**DATE:** August 18, 2023.  
**TO:** Users of ATS480 soft starters.  
**FROM:** Schneider Electric Drives Activity.  
**SUBJECT:** ATS480 Manual Modification

We have recently discovered an error in our ATS480 user manuals (**Power Connections ATS480C14Y...ATS480M12Y** section of **Wiring** chapter). This issue does not require any return, repair or replacement of the soft starters. This issue requires some caution in building your electrical equipment. The soft starters meet all quality requirements, however the User Manuals listed below have an incorrect power terminal representation depicted.

**Wrong representation (bottom view)**

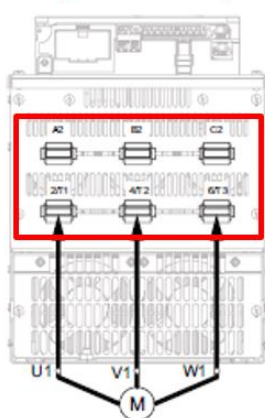
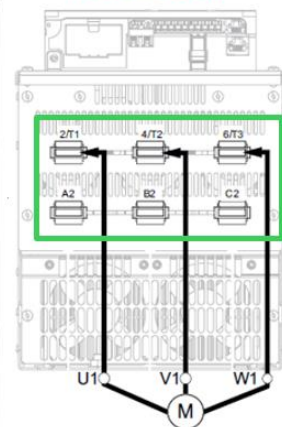
The error concerns the power terminals representation of the bottom part of the ATS480:  
 2/T1, 4/T2, 6/T3 outputs to motor have been reversed with A2, B2, C2 Soft Starter Bypass. If the user connects the wrong wire to the wrong terminal, the equipment will not work.

For any on-going or future design and manufacturing of bus bars to connect terminals of the soft starter to by-pass contactor, use the correct representation shared in the most updated manual (**NNZ85515.04**).
